Additional Electrical Knockouts added to PS Product Line

August, 2000

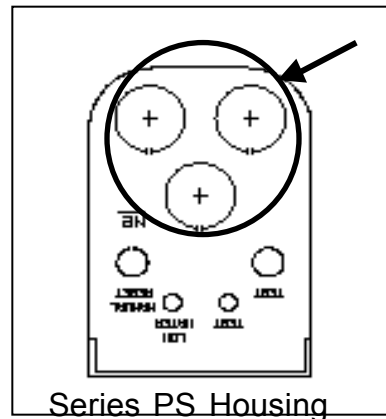
Three electrical knockouts have been added to all Series PS housings. The additional knockouts are located on the opposite side of the control housing relative to the existing ones.

The dimensions of the PS housing have not been changed. The drawing below illustrates the location of the additional electrical knockouts. The circled area specifically points out the modification.
